Subject: Three Mile Island Nuclear Station, Unit 1 (TMI-1)
DPR-50/Docket No. 50-289
Three Mile Island Nuclear Station, Unit 2 (TMI-2)
DPR-73/Docket No. 50-320
Oyster Creek Nuclear Generating Station (OC)
DPR-16/Docket No. 50-219
Revised Corporate Emergency Plan - Revision 10

Enclosed is one copy of the GPU Nuclear Emergency Plan, Revision 10.

ATTACHMENT
SPECIFIC CHANGES

FIGURE 3: OCNGS SITE ARRANGEMENT

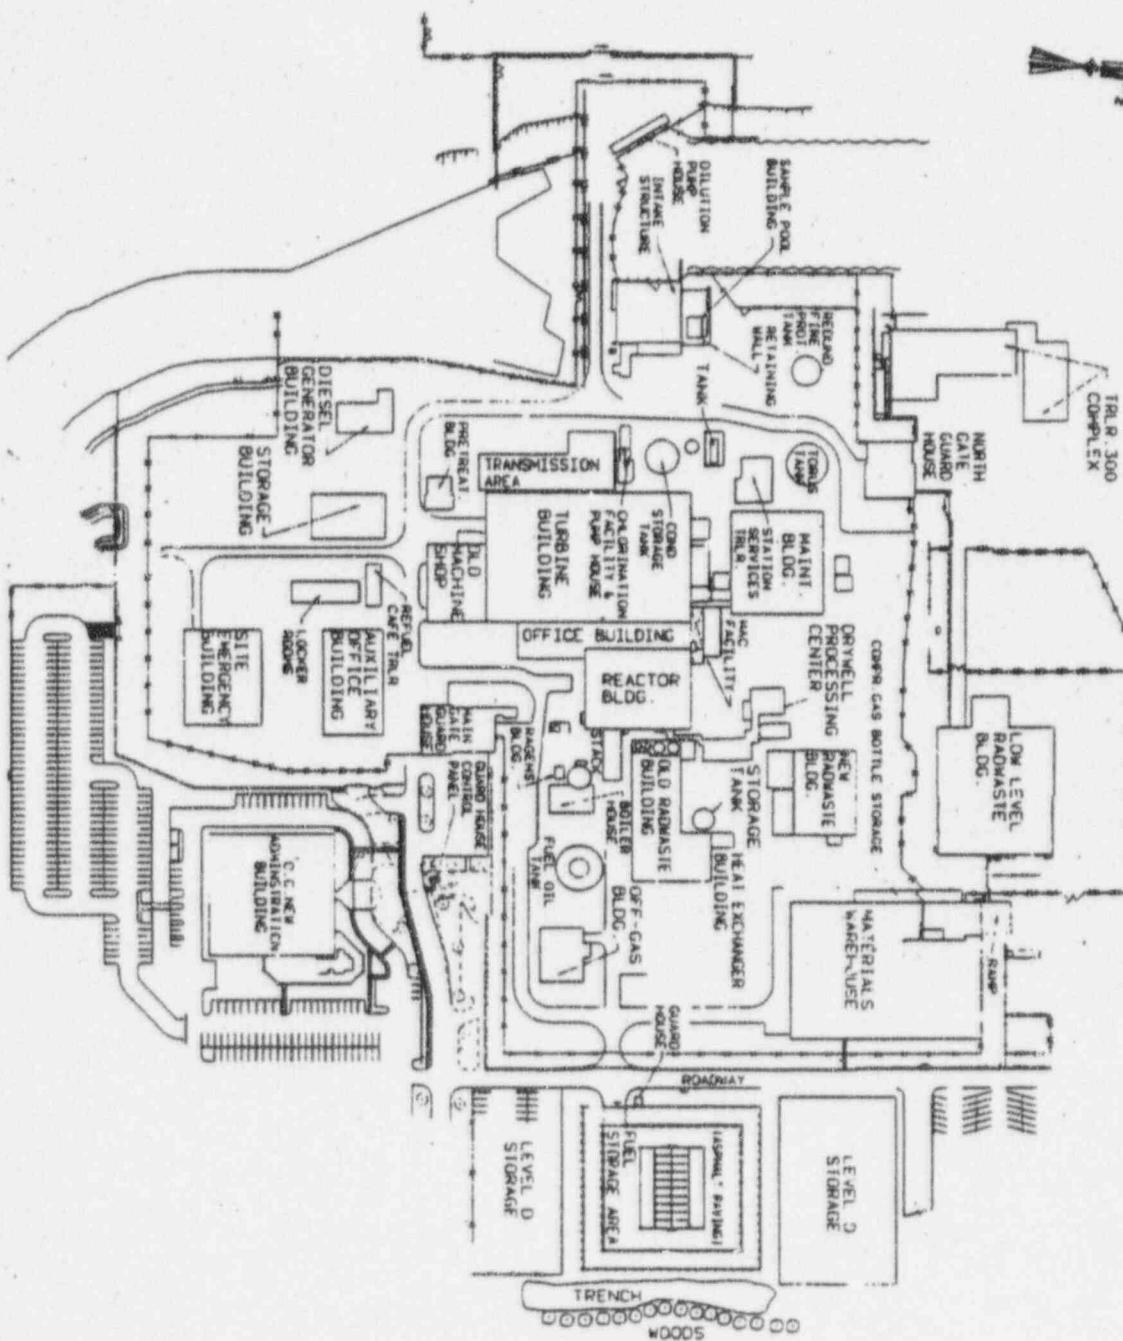
25. Old Table 16 - Emergency Response Organization staffing responsibilities - Table has been revised to reflect latest GPUN reorganization.
26. Figure 3 - OCNGS Site Arrangement - replace with current map.
